Surface Cable Connector Issues from the 2004-05 Pole Season

John Kelley and Johan Lundberg
January 16, 2005

Figure 5a: Example of Connector with Bent Pins (Ericsson Cable)

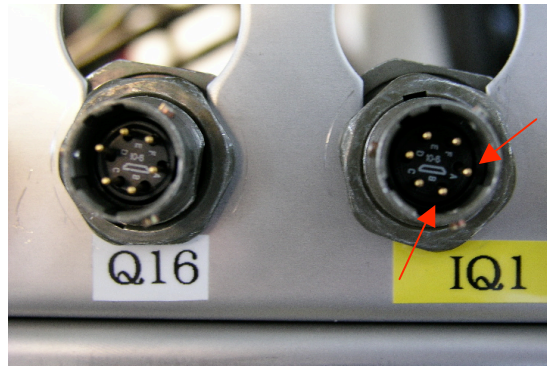
Upon unwrapping the MS connectors of the surface cable at the TCH and placing them in the patch panel, we noticed that a significant fraction (at least 10%) of the connectors had visibly bent pins. The pins are not so badly bent that they can't be straightened; however, this makes connections much trickier, and if the same situation occurs at the SJB, the detail work required outside could be quite difficult. Even inside, one patch cable connection took 1/2 hour, because the pins were bent in a symmetric way that was difficult to detect.

With the Ericsson cables, it was clear that this was the first time the connectors had been unwrapped since delivery, indicating that the pins were bent at some point prior to shipment.

- Better quality control after production, including checking the gender and pins of all connectors
- Sturdier packaging of connectors during transport, and/or more careful handling during deployment
- Shipping spare connector kits of all genders and pin configurations to the pole for use in fixing any of these problems that occur in the future
